**Boliden Tara Mines Tailing Management  
Facility (TMF) Industrial Emission Licence  
Review**

**Assessment of Proposed Stage 6 TMF Extension  
Expert Report**

**Document No. L116-17-R2418**

Figure 5.1  
 Slope Stability Analysis Model

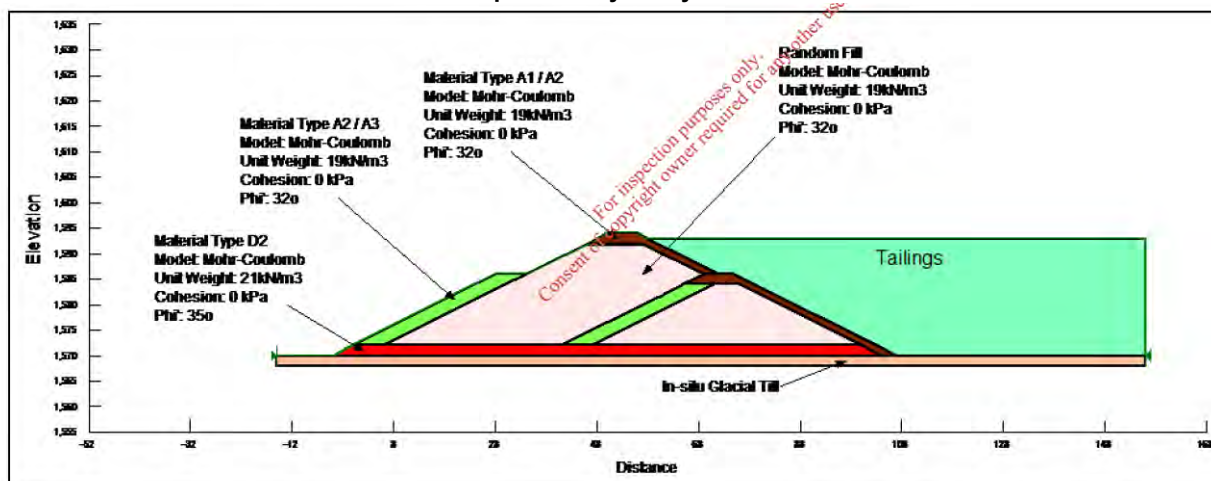
*“The model geometry is based on a typical cross-section of perimeter dam wall at full height (67.29 m AOD) including the bench at 59.29 m AOD.....The geotechnical strength parameters adopted in the stability modelling are presented in the table 3.10 and the geometric configuration presented in Figure 3.14.”*

**Figure 5.2**  
**TMF Composite liner**

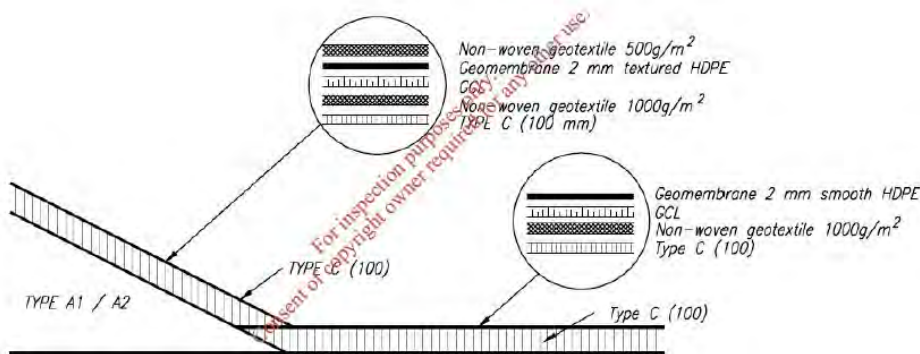
It is understood that “A leak detection survey using DC electric current will be undertaken after the installation of the lining system.”
